# WASHINGTON NAVY YARD SOUTHEAST CORNER MASTER PLAN

## Introduction

- Following the CFA Commission presentation on November 16, 2023, a letter was issued requesting additional information and revisions to the Washington Navy Yard Southeast Corner Master Plan.
- The following presentation will provide the context for how the Southeast Corner Master Plan developed to respond to the Commissions requests.
  - Building Heights and Massing
  - Views Within and Through the Development
  - Character of the Riverfront
  - Public Green Space
  - Historic Resources
  - Project Benefits

### **Comparable Building Heights along the Anacostia Waterfront**

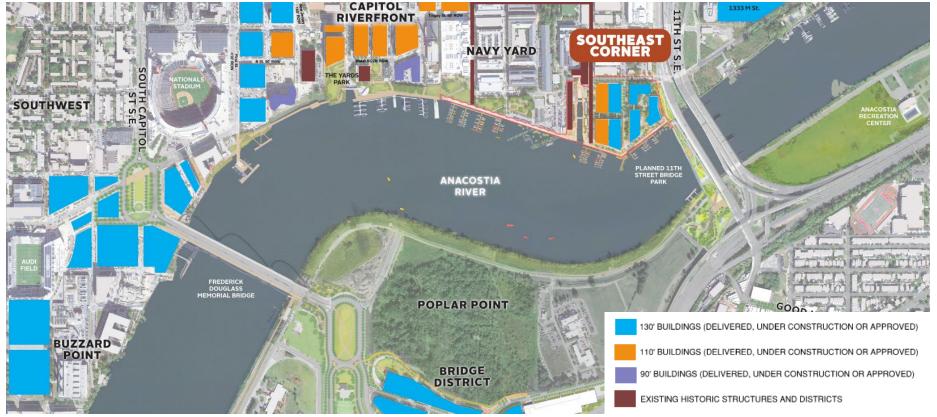
"Finding that the nearest building comparable height along this part of the Anacostia waterfront is nearly a mile away, the Commission members raised concerns about allowing this height on the southeast parcels. They also noted that the grade of the site is being elevated roughly a story of flood protection, and that current building height regulations allow an additional twenty feet of occupiable penthouse structures; altogether, the proposed 130-foot height would result in a massing that is roughly 160 feet above the current riverwalk. They therefore requested the development of an alternative that incorporates lower building heights generally along the riverfront. In addition, they cited the importance of maintaining a full 75-foot setback at the riverfront, and they recommended against any upper-level projection of the new buildings into this setback."

- The Commission requested information on the height of buildings along the Southeast waterfront.
- Parcels highlighted in blue represent buildings delivered, under construction or approved to be 130' in height with adjacent ROW widths of 110' or greater.

Highlighted buildings are within a 1-mile radius of the Southeast Corner. The heights of buildings in the WNY Southeast Corner Master Plan are consistent with development patterns along other areas of the southeast waterfront.

- Parcels highlighted in orange represent buildings delivered, under construction or approved to be 110' in height. These buildings are also adjacent to historic structures and on streets with 90' ROW widths.

- Parcels highlighted in purple represent buildings delivered, under construction or approved to be 90' in height. The height of these buildings is based on adjacent street widths with Parcel Q in the Yards on Water St. (70' ROW) and the DC Water Headquarters on Canal St. (80' ROW). The height of these buildings was restricted to below 110' because of the width of the adjacent ROW, not their location on the waterfront.

VIEW FROM THE APPROXIMATE LOCATION AND ELEVATION OF THE FUTURE CAPITOL OVERLOOK

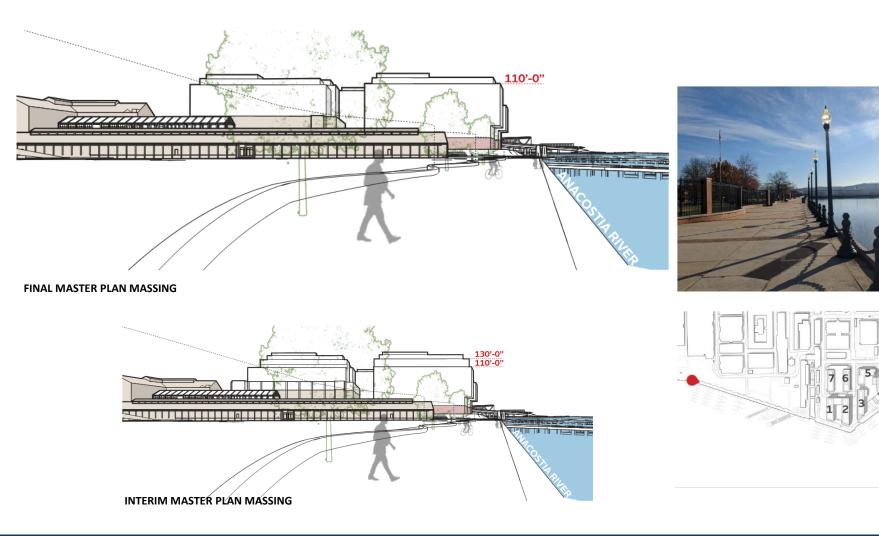
"The Commission members asked for more studies of views that demonstrate the impact of the development, including from the Capitol Overlook of the 11<sup>th</sup> Street Bridge Park to the city's monumental core, as well as views to the Anacostia River from locations within the development and from the adjacent parts of the Navy Yard."

- The current viewshed from the Capitol Hill Overlook to the U.S. Capitol Dome is blocked or limited due to existing heritage trees in the Washington Navy Yard.
- The viewshed along the 11<sup>th</sup> Street Bridge to the monumental core is not a protected viewshed in the L'Enfant Plan.
- Views of the monumental core and other landmarks will remain visible from sections of the 11<sup>th</sup> Street Bridge Park including the main public amphitheater.
- The Navy, Redbrick and the 11<sup>th</sup> Street Bridge Park teams have worked together to identify future areas of collaboration to enhance the physical connection points between the projects, engage the public and expand on future programming and events.
- This team collaboration is already underway and will expand as the site plan and design continues to develop.

Following team collaboration, the 11<sup>th</sup> Street Bridge Park and Building Bridges Across the River submitted a letter of support for the WNY Southeast Corner Master Plan to both the NCPC and CFA Commissions

## **Potential Design of the Linear Park**

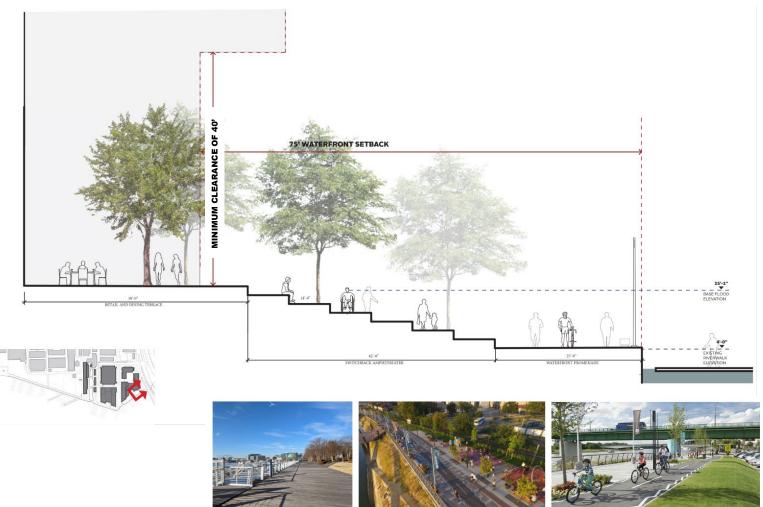
"Noting the 11-foot increase in elevation proposed within the 75-foot setback, the Commission members asked for more information about the potential design of this linear park, which they said requires punctuation with nodes of activity to be successful public space. They observed that ground-level restaurants within the outdoor service areas often require controlled access and should not extend into the 75-foot setback."

The linear park will be designed to meet Design Goals within the PA including *"to create new amenities that integrate into and enhance the Waterfront Zone"* and *"to maintain and enhance public access wherever possible".*

### **Publicly Accessible Green Space**

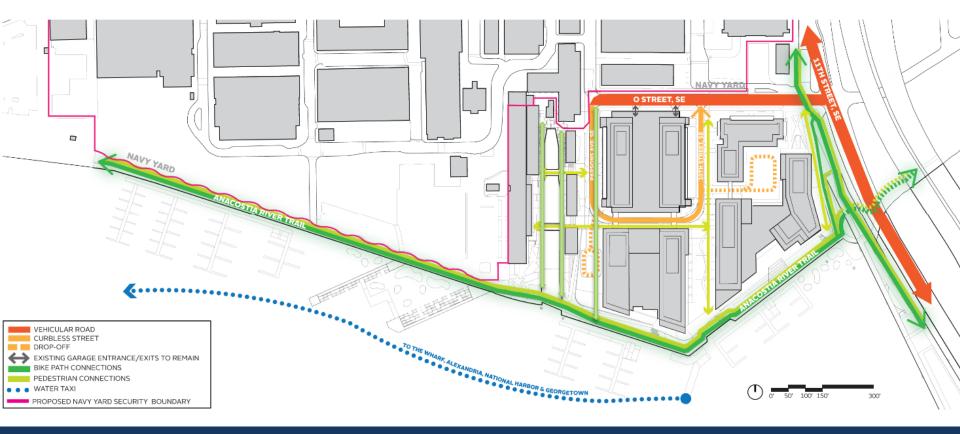
"The Commission members commented that the large development, proposed to be more than 2 million square feet, should include substantial, publicly accessible green space; they asked for more clarification in the plans regarding which areas are already public (such as the riverwalk), how much of the open space would be paved versus planted, and what landscaped areas (such as residential amenity areas above the service plinths) would be publicly accessible or privately controlled. They emphasized the importance of accessible connections through the site to the waterfront."

As stipulated in the PA, trees and landscape beds will be used sparingly to preserve the character of historic industrial use. Landscape beds and trees that are compatible with the historic setting in terms of design, number and other details will be incorporated into the design and will be part of the ongoing consultation and Design Review process established for each building within the WNY Southeast Corner Master Plan.

## **Incorporation of a H-Shaped Building**

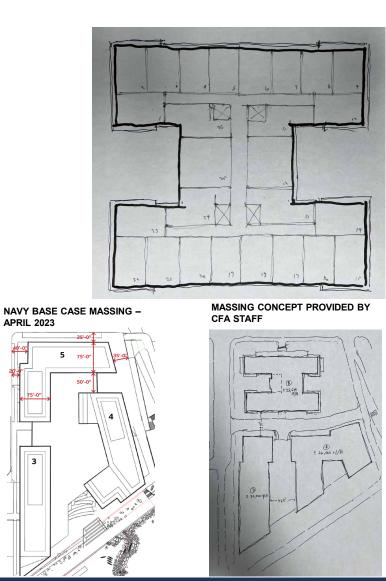
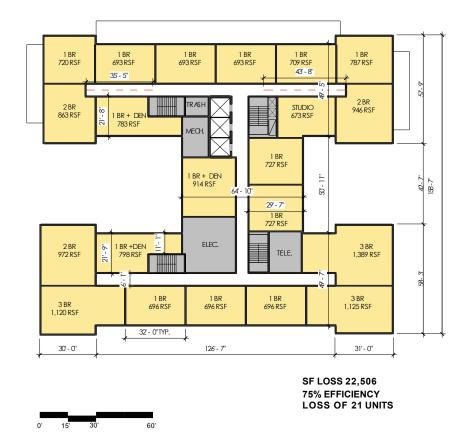
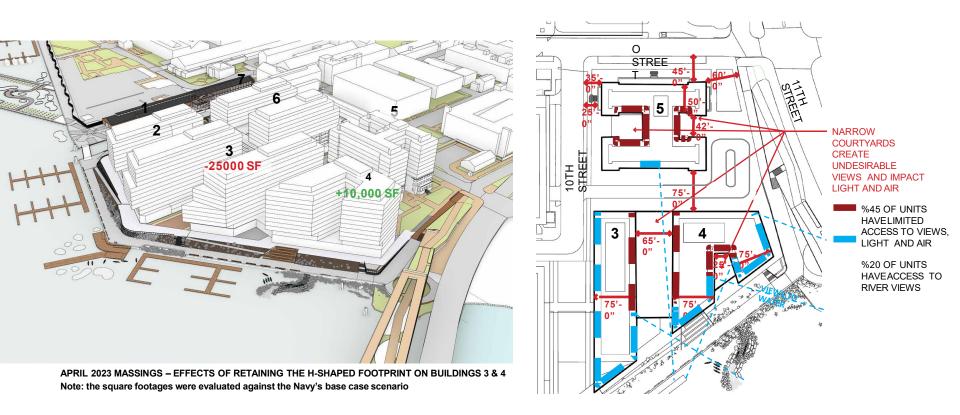
"In support of preserving the existing landmark and contributing historic structures that were part of the Navy Yard, the Commission members requested development of an option for Building 166 that maintains its entire historic H-shaped footprint and perimeter walls."

Interior layout studies of the H-Shaped building resulted in a building plan that was inefficient.

A layout provided by CFA staff was modified to study the potential unit layouts of an H-shaped residential building. The initial loss of gross square footage was 22,500 from the Navy's base case scenario.

Consultation also included an evaluation on retaining the entire H-shaped footprint and perimeter walls.

Building 166 was originally designed as an office building. Retaining the H-Shaped building footprint and adapting it for residential use resulted in a decrease in the building's efficiency, negative impacts to units' access to views, light and air, and a decrease in the gross square footage of the project, all of which severely effected the economic viability of the project.

# **Building 166 Setback Analysis**

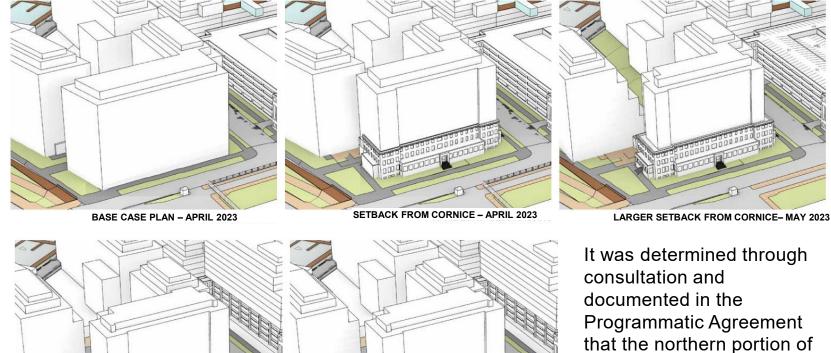
The Consulting Parties provided feedback on how the existing facades would interact with the new construction building including an examination on the setback from the retained base.

FINAL PREFERRED MASSING WITH NO SETBACK- MAY 2023 B166 would be retained and incorporated into a new construction building.
